DEXTER TOWNSHIP

ZONING BOARD OF APPEALS

Petition Number:	<u>(23-ZBA-006)</u>
Applicant(s):	Bradley Devries on behalf of Corn Man, LLC
Project Description:	Construct a pavilion with enclosed walkways in excess of the maximum lot coverage for buildings
Petition Description:	a) Request for variance from Section 16.12 requiring a maximum lot building coverage be 11,543 sq.ft.
Property Location:	8540 Island Lake Road, D -04-36-400-002

DATE: April 16, 2013
TO: Dexter Township Planning Commission
CC: Alex & Kelly Young (*Applicants*), Todd Pascoe (*Applicants' Engineer*), Chuck Bultman, (*Applicants' Architect*),
Matthew Parks, PE (*OHM Engineering Services*)
FROM: Zach Michels, Director of Planning and Zoning
RE: (13-PC-147) Cornman Farms Special Land Use and Preliminary/Final Site Plan Review v04.16

ENGINEER'S SEAL
NO SCALE
DRAWN BY: EMM
CHECKED BY: DB
PROJECT MANAGER: TP
CAD FILE: 12001467SP-1.0-CV
JOB #: 12001467
FILE CODE:
SHEET NO.
SP-1.0

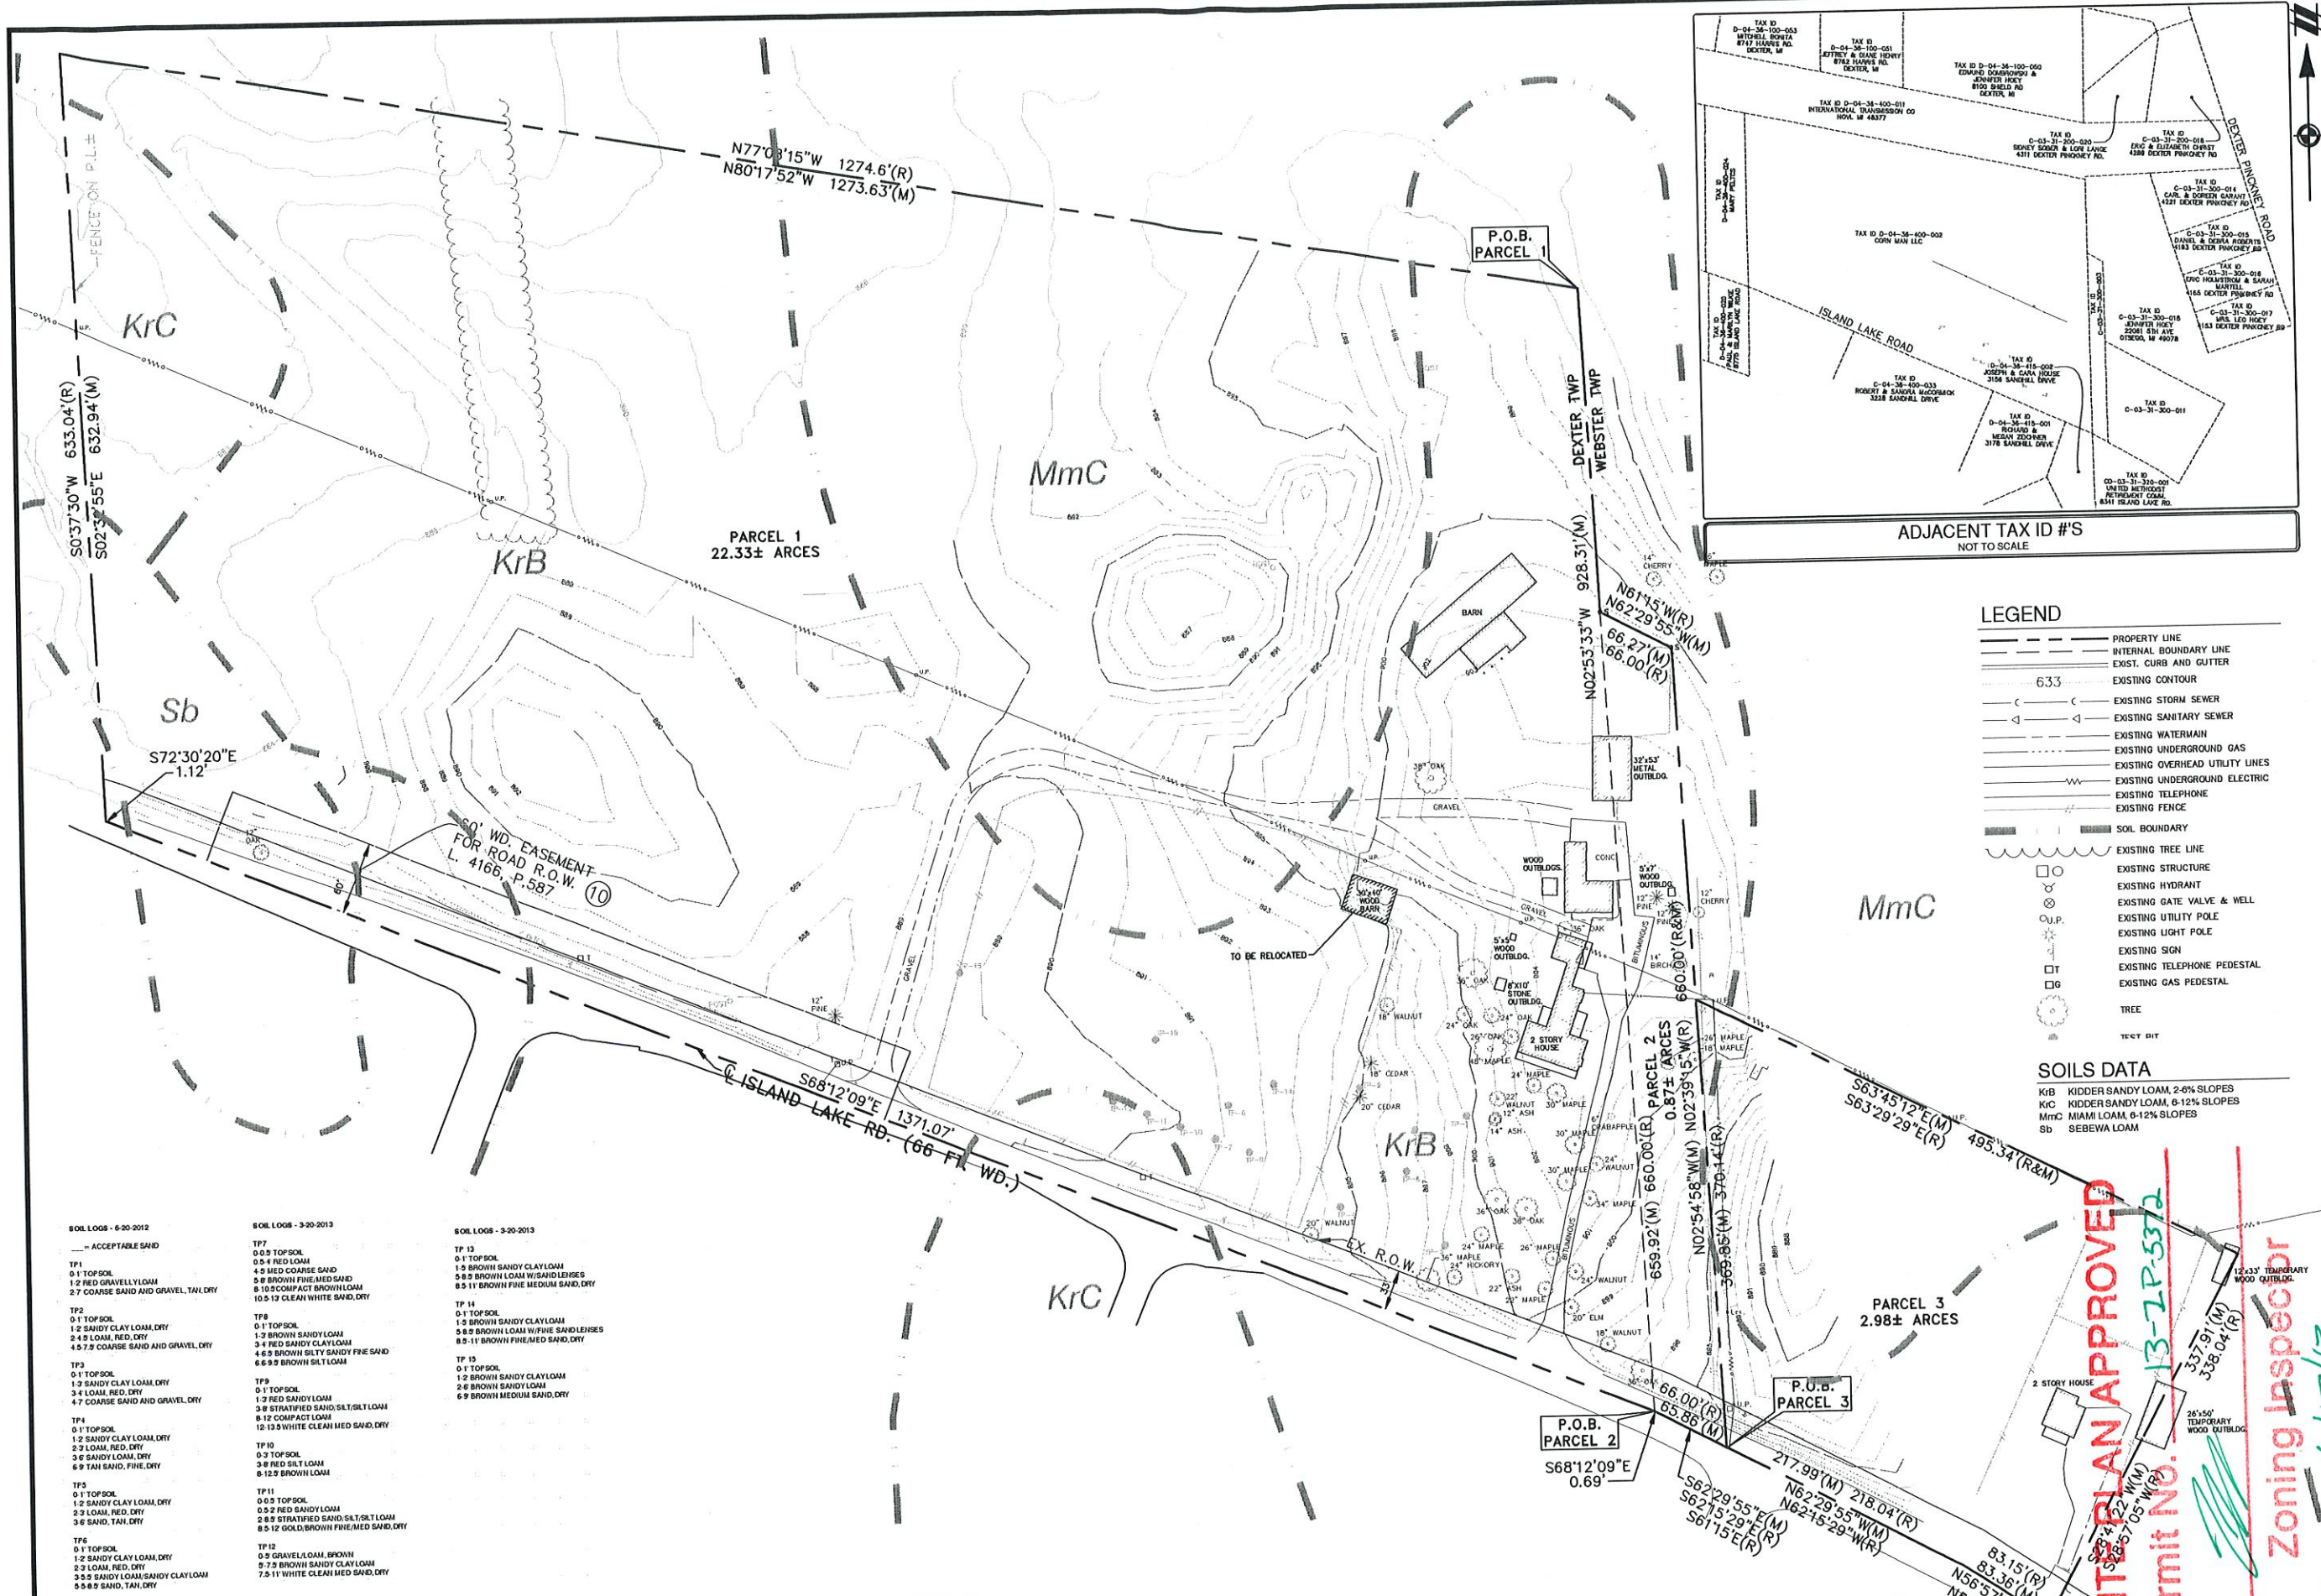
6.03(B)(14)	Completion Schedule	YES	Sheet Number SP-1.0 indicates site work and building modifications will take place in 2013 with the facility opening in Spring 2014.

6.04(B)(2)	Traffic Impact Study	NO	It is likely that the proposed special event facility may generate 100 or more vehicle trips in a day. (Sheet Number SP-1.0 indicates up to 20 staff members and a capacity of 196-250 patrons.) The applicant states that the Washtenaw County Road Commission will not require a traffic study as part of its review. If the Planning Commission would like a traffic impact study as part of the special land use/site plan review, it should direct the applicant to provide one.

ENGINEER'S SEAL
SCALE: 1"=50'
DRAWN BY: ENM
CHECKED BY: DB
PROJECT MANAGER: TP
CAD FILE: 12001467SP-4.0-G
JOB #: 12001467
SHEET NO.
SP-4.0

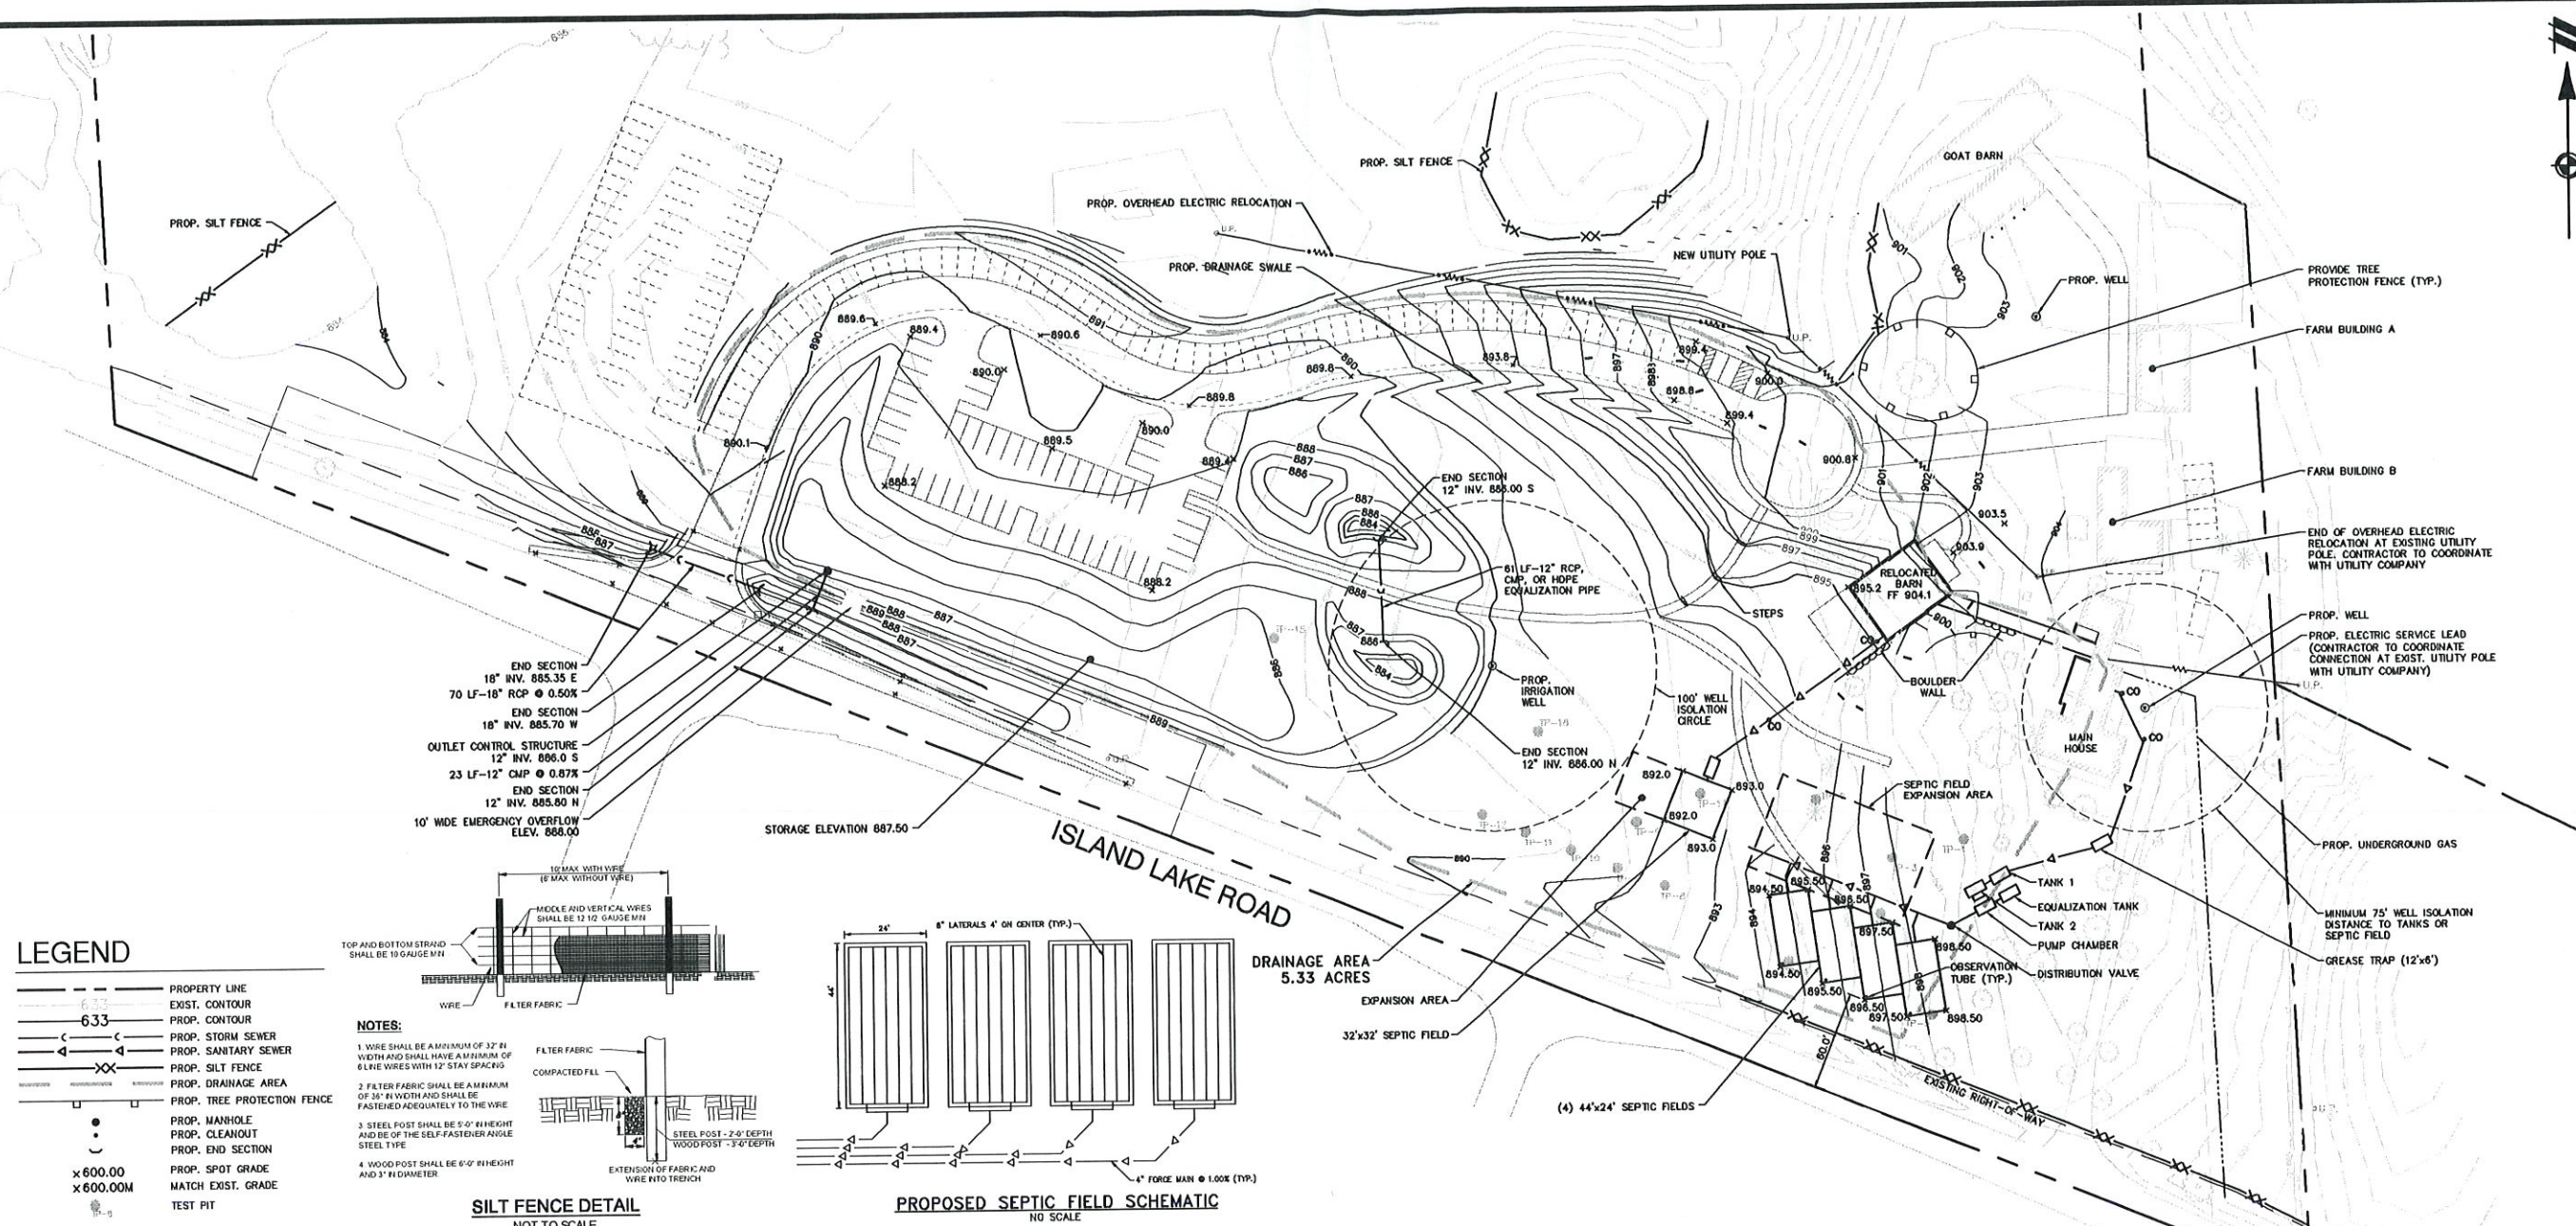
7. The "Typical Gravel Cross-Section" on Sheet SP-4.0 proposes grade slopes of 1:3. We recommend that the slopes are reduced to 1:4 or appropriate stabilization measures and/or plantings are shown. This is particularly important where the 5-foot pathway is being proposed adjacent to the 1:3 slope.

ENGINEER'S SEAL
SCALE: 1"=50'
DRAWN BY: EMM
CHECKED BY: DB
PROJECT MANAGER: TP
CAD FILE: 12001467SP-6.0-LT
JOB #: 12001467
FILE CODE:
SHEET NO.
SP-6.0

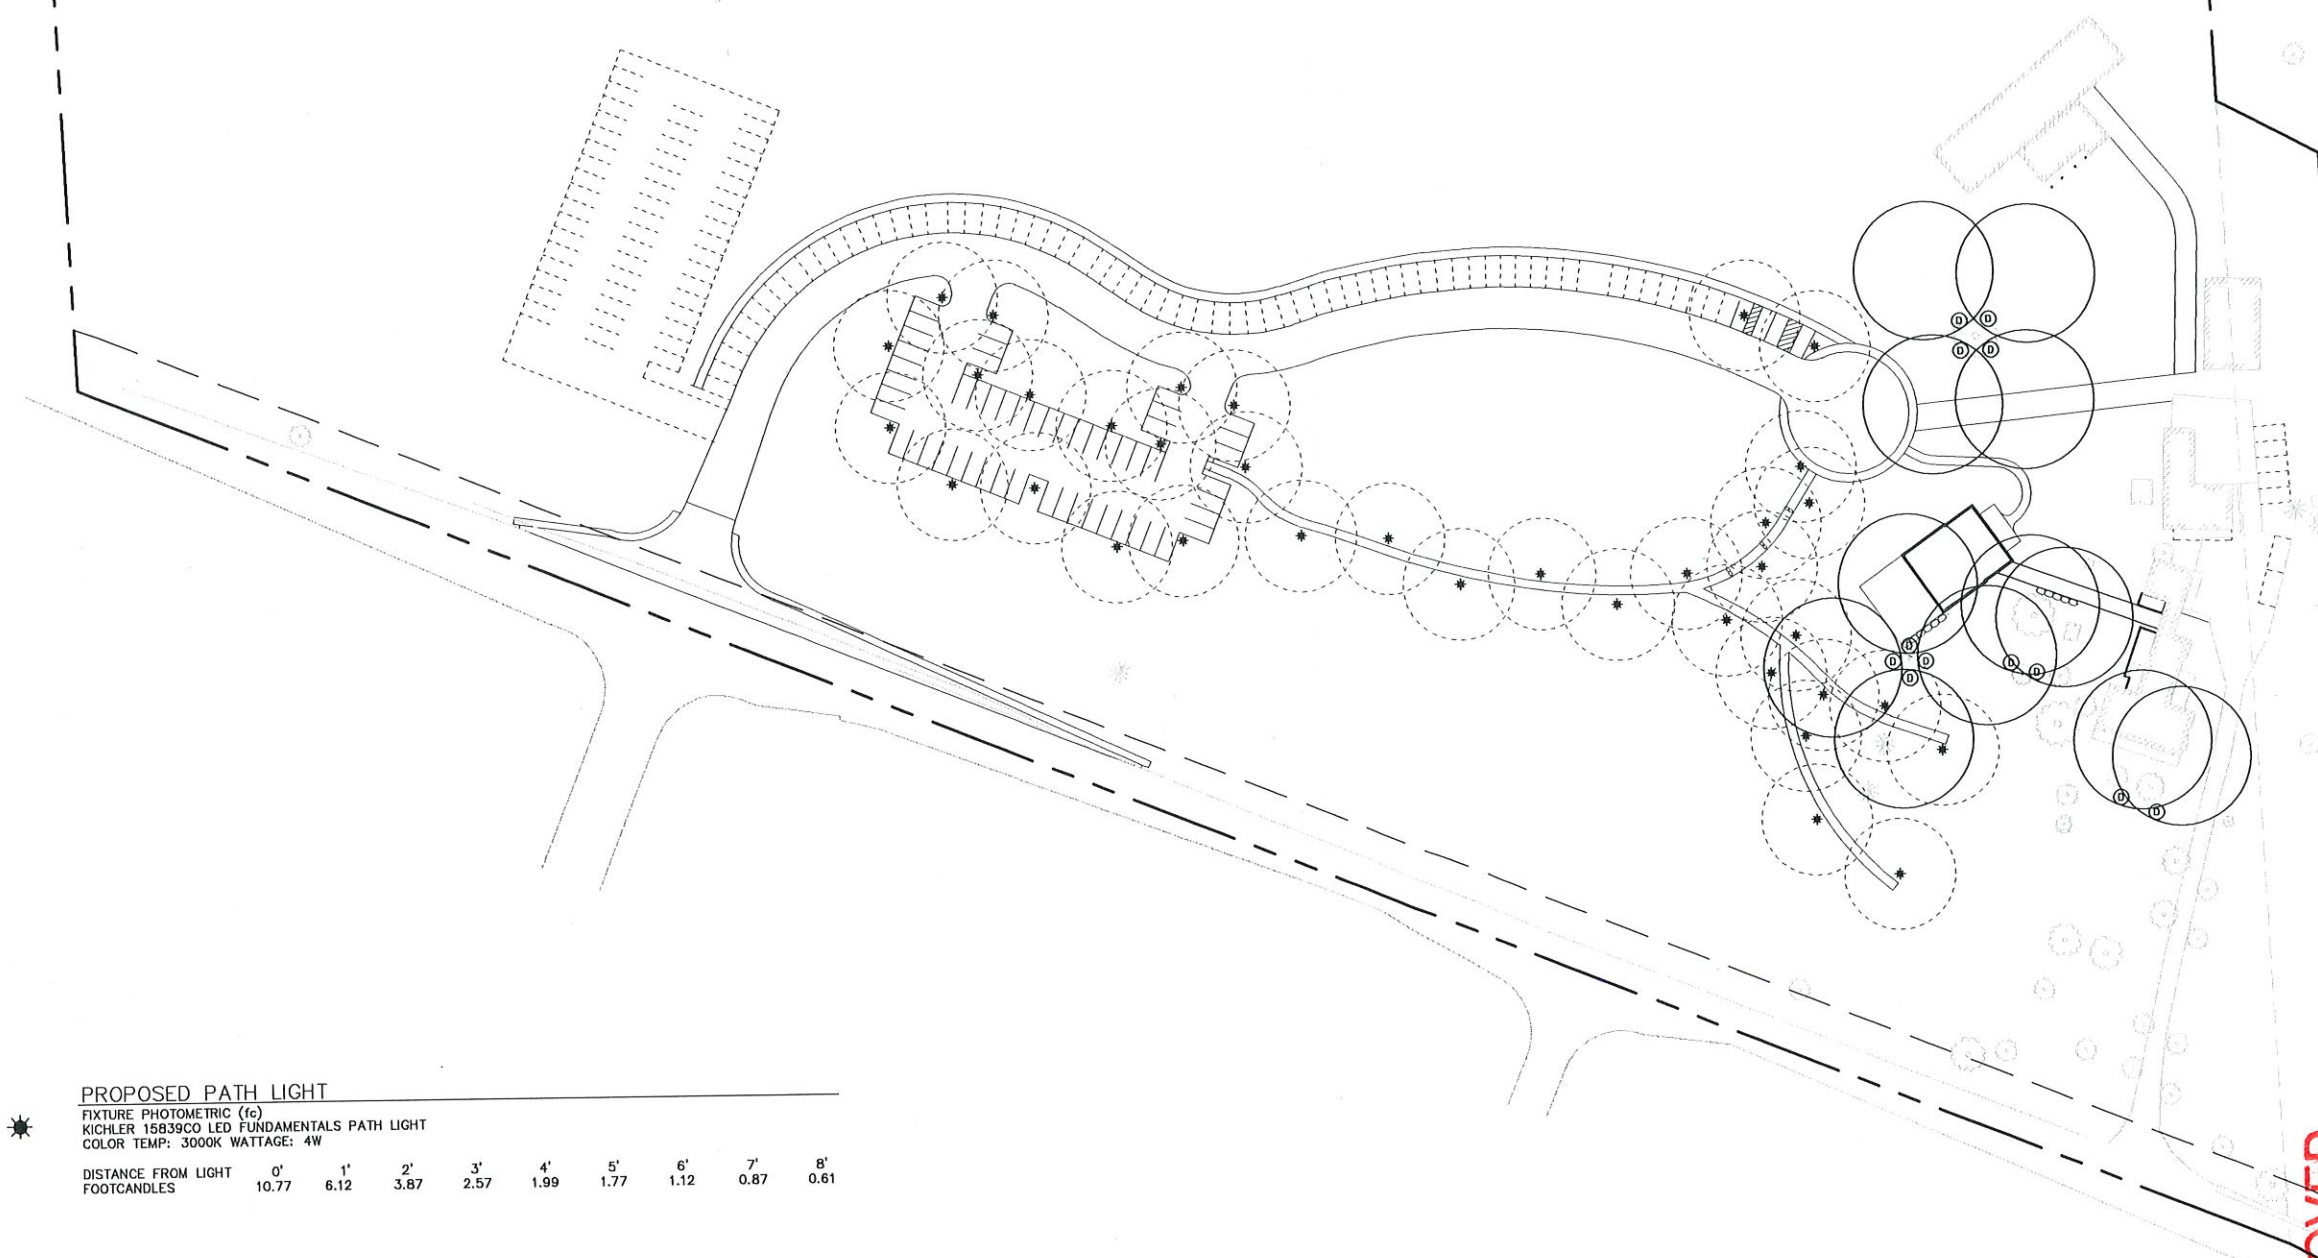
Sheet Number SP-6.0 and 6.1 provide details about the location and type of lighting to be installed in the parking areas and along walking paths. It appears that the proposed lighting meets the standards of the zoning ordinance.
